**Subject:** Planning Application 2017/4582/P 2 Eldon Grove -Consultation reply

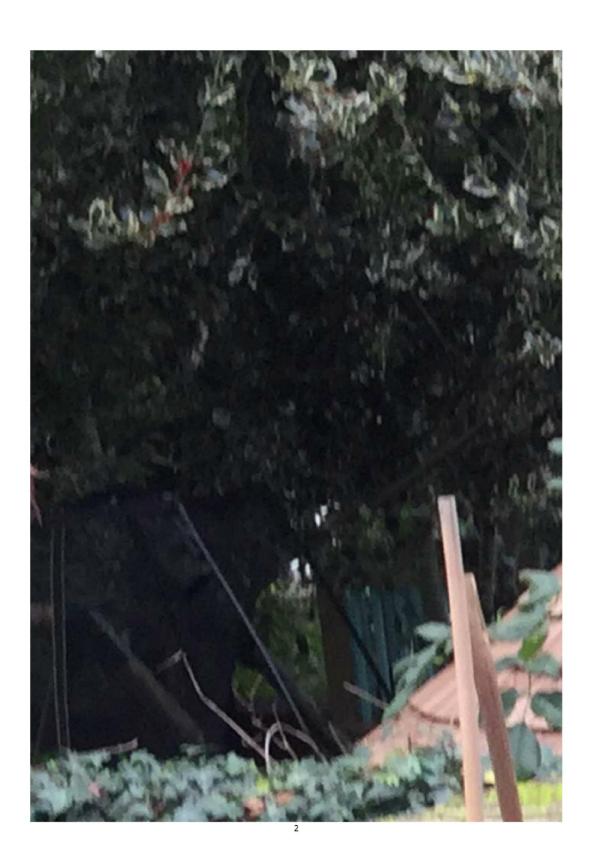
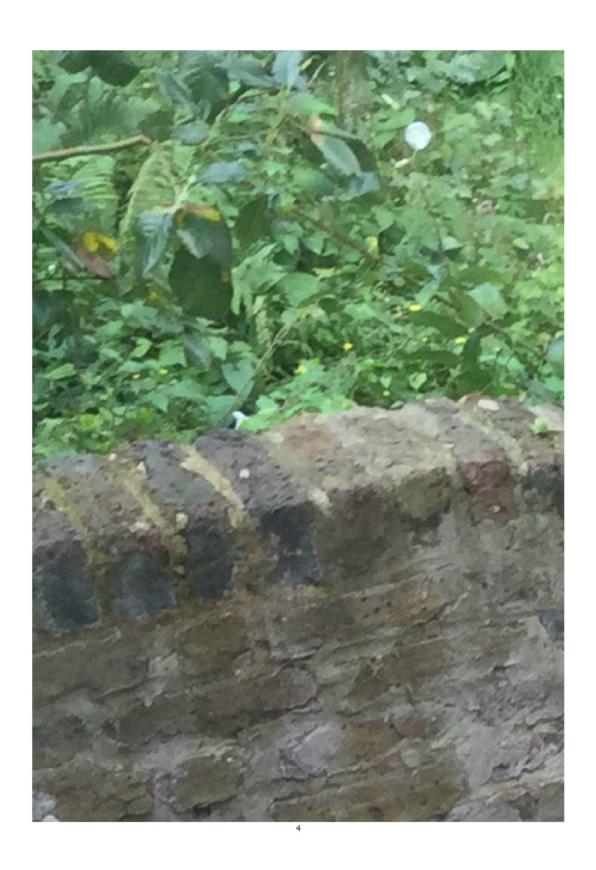
Without planning permission the owners of 2 Eldon Grove, who moved into their property around 6 months ago, have erected in their large back garden a number of tall structures/outbuildings in very close proximity to neighbours' property and gardens. I have lived here for over 30 years and from my rear window and garden I have enjoyed the tranquil and verdant aspect of the surrounding back gardens. Now I look out at the unattractive roof of a gazebo (see photo attached) and when I sit at my back garden table I look at the complete roof of the gazebo (see photo attached).

As well as being highly visible as described above, the gazebo continues to shed rainwater onto its very thick 5-10 square metre plinth abutting my kitchen wall and damp course. There is no provision to direct rainwater from the hard surface to a porous or permeable area within the owner's garden boundary. Puddles are the result.

Incidentally, the gazebo touches the garden wall of 3 Eldon Grove- not with a few inches gap as shown in the sketch.

As a structure over 2.5 metre (2.9 metres) in height it should be more than 2 metres from my property as well as from the garden wall of 3 Eldon Grove.

I request that the gazebo and associated plinth and electrics are removed completely
